Light Rail Transit Accommodation

How is light rail transit accommodation addressed in the preferred alternative?

Mid-span cross section - Seattle Mayor's Report on LRT Accommodation, showing wider cross-section.

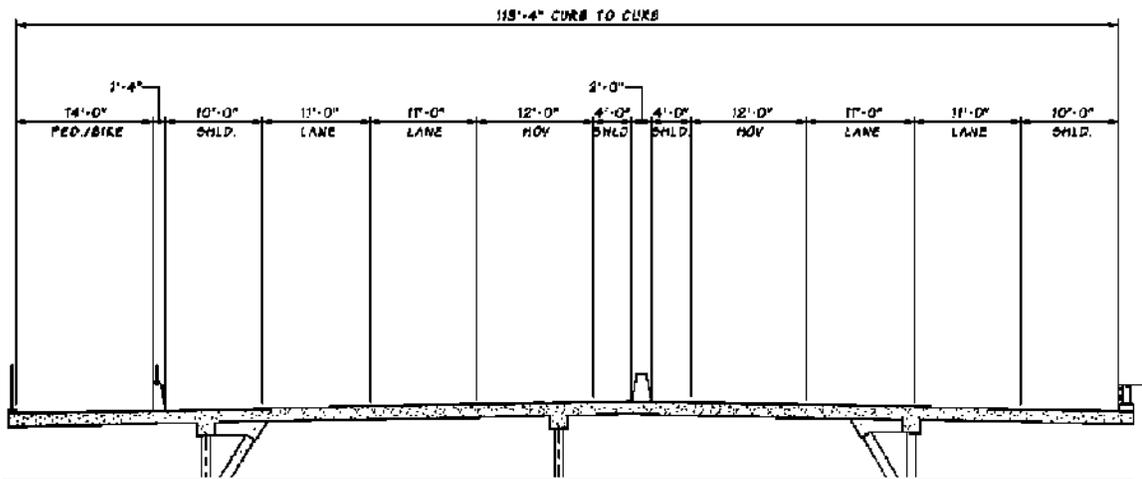
SDEIS: The report found that the roadway structure currently under design accommodates future LRT by including structural elements and stray current protection for LRT. The question that was raised was the potential need for a wider roadway structure. The report found that it could be necessary to widen the bridge deck up to ten feet, from 115 feet up to 125 feet, to support conversion to light rail. This was based on a combination of engineering factors

provided by Sound Transit and an assumption that the shoulder widths were at a minimum width that was acceptable to FHWA.

Preferred alternative resolution: In subsequent work on the design, WSDOT found that by reducing shoulder widths on the bridge deck and assuming LRT operation in a smaller design envelope (34.3 feet compared to 38 feet from outside of barrier to outside of barrier), LRT could be accommodated within a 115-foot roadway section.

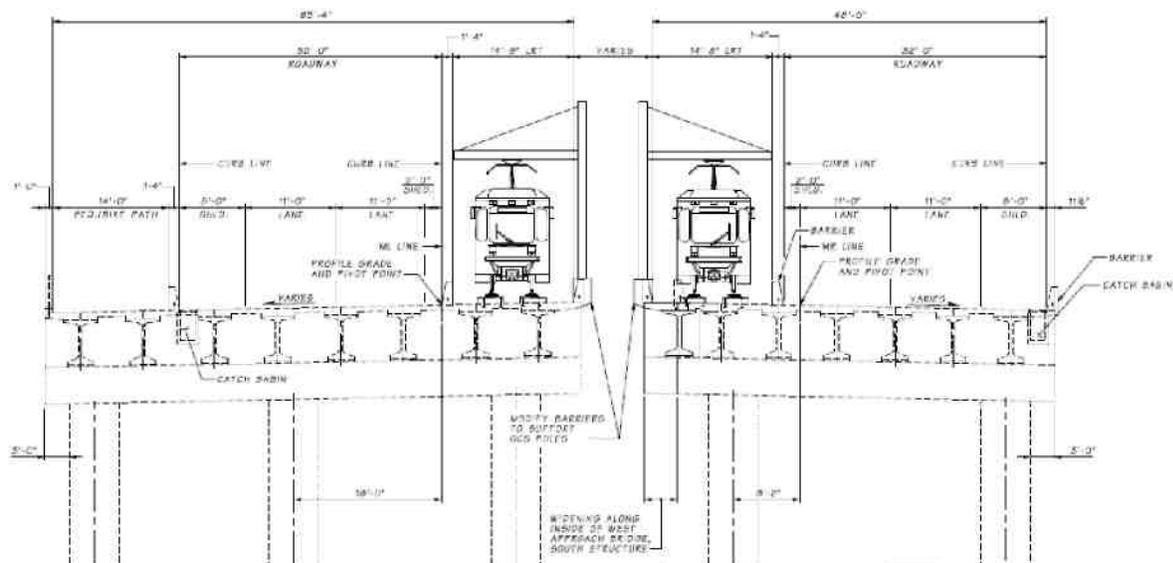
SDEIS: The pontoons for the bridge as designed in the SDEIS, are capable of supporting a six-lane roadway section. The number of pontoons was insufficient to carry the six-lane roadway structure plus the added load and stability requirements necessary to accommodate LRT.

To support a six-lane structure the design includes a single string of longitudinal pontoons and supplementary stability pontoons, or “flankers,” to be attached at periodic intervals to the longitudinal pontoons. The “flankers” are designed to provide the floatation and stability needed for a 6 lane roadway. With the addition of the LRT to the bridge, more flankers are needed to provide floatation and stability to accommodate the added weight and dynamic load.

Preferred alternative resolution: To support the additional loading of LRT, an additional 30 “flanker” pontoons would need to be added to the bridge. It should be noted that the technology and method for attaching these “flankers” is well known as the first phase of the six-lane bridge requires 14 “flanker” pontoons, and is the same pontoon joining process as used for all current floating bridge pontoons.
